Proposed Revisions to a Standard Plans Index

Date: June 15, 2021 Originator: James McGinnis Phone: (850) 414-4952 Email: james.mcginnis@dot.state.fl.us **Summary of the changes:** Index Number: 102-613 Sheet Number (s): 1 and 5 of 5 Index Title: Multilane Roadway, Lane Closure

MULTILANE ROADWAY, LANE CL

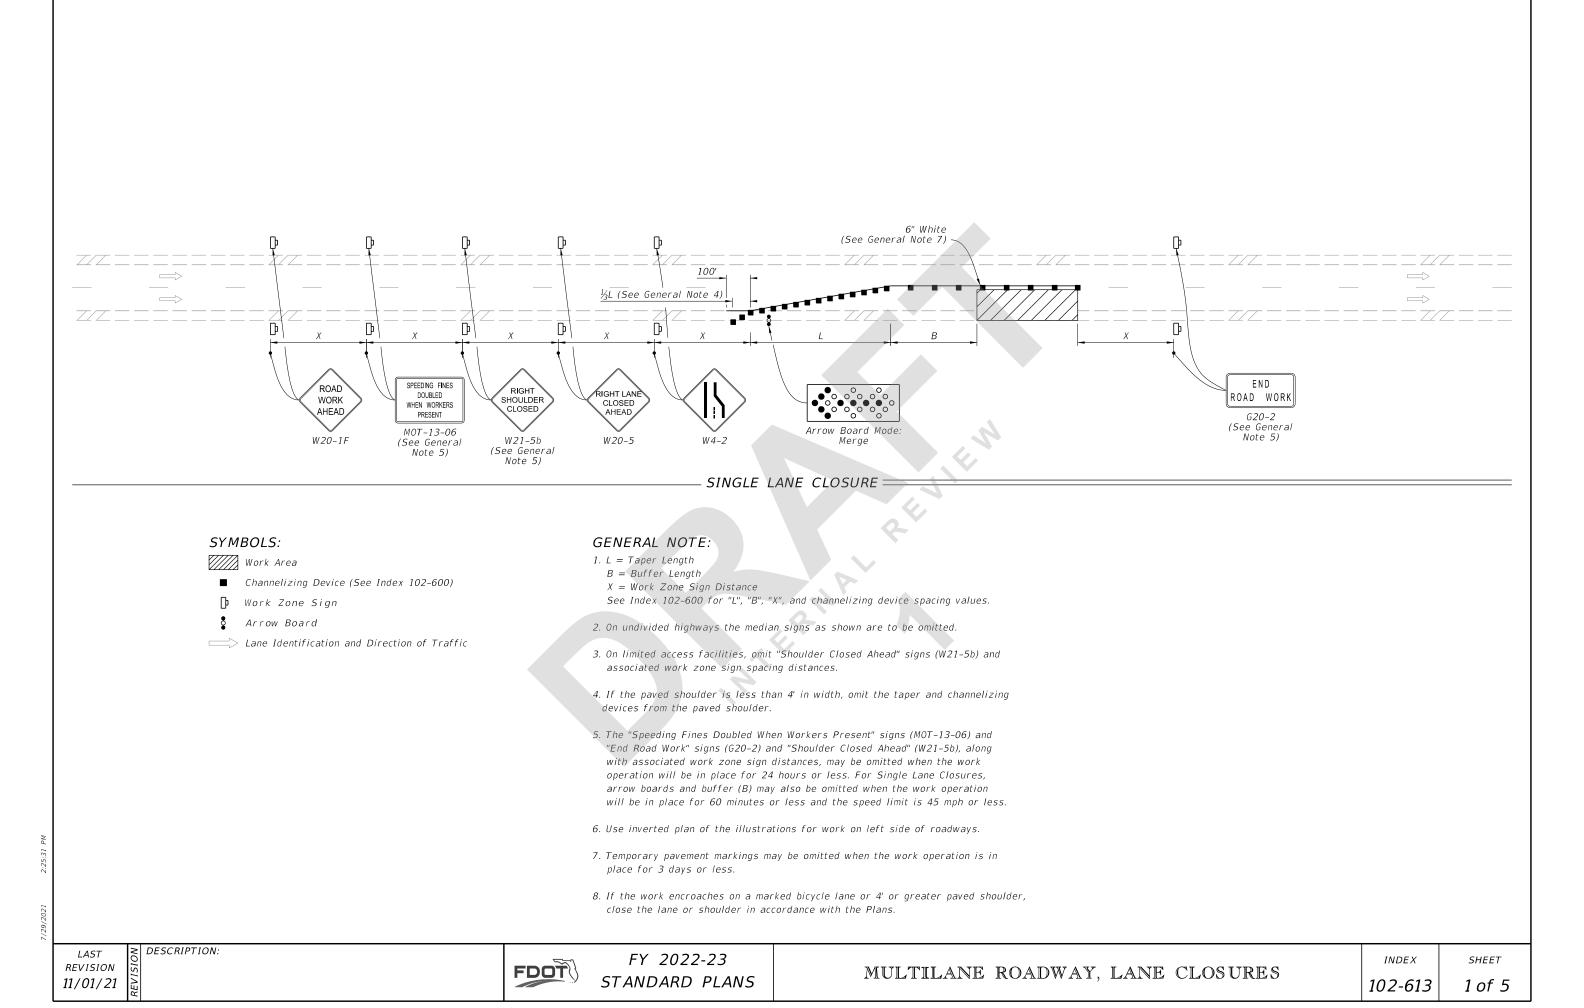
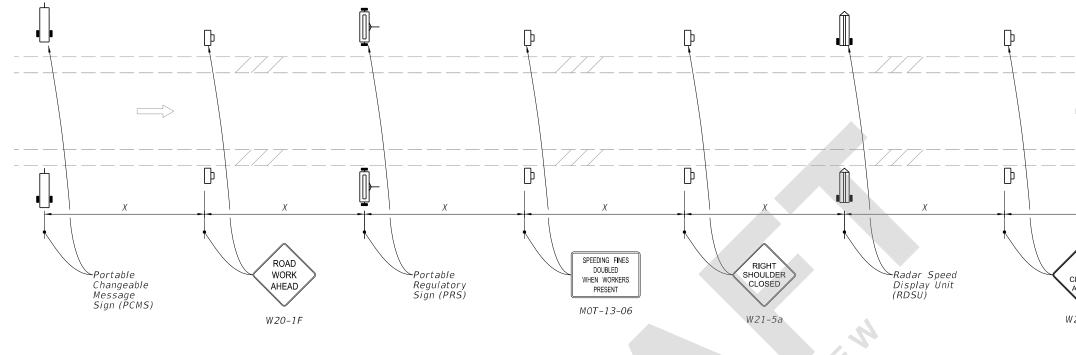
Sheet 5: Added MAS usage note back from 2018-2019 Standard Plans.

Sheet 5: This note was added back to the Standard Plans to help clarify when to use the MAS system. The note was removed and added to the FDM in 2020 however, this created confusion when to use the MAS for shorter duration projects on lower speed roads.

SYMBOLS: NOTES: 7 1. Use the Motorist Awareness System (MAS) for lane closures of at least 5 days (consecutive or not) on multilane divided facilities with a posted speed of 55 or greater when workers are present and not protected by a barrier. ŀ Work Zone Sign (1) PCMS= Portable Changeable (Variable) Message Sign 2. Locate the Motorist Awareness System (MAS) devices (i.e., PCMS, PRS, and RDSU) within the advance warning signs as shown. Continue with the remainder of the work zone signs and devices in accordance with Image: Hard Control of the second the Plans or Standard Plans after the appropriate "Lane Closed Ahead" (W20-XX) sign. 3. For a posted speed of 65 mph or greater, display (2) RSDU= Radar Speed Display Unit speed with a ten mph reduction. For a posted speed of 60 mph, display a reduced speed of 55 mph. For areas outside of the lane closure, use the posted speed as the work zone speed. Lane Identification and Direction of Traffic 4. Omit the PCMS in the median for roadways with three lanes or less in the same direction of traffic.
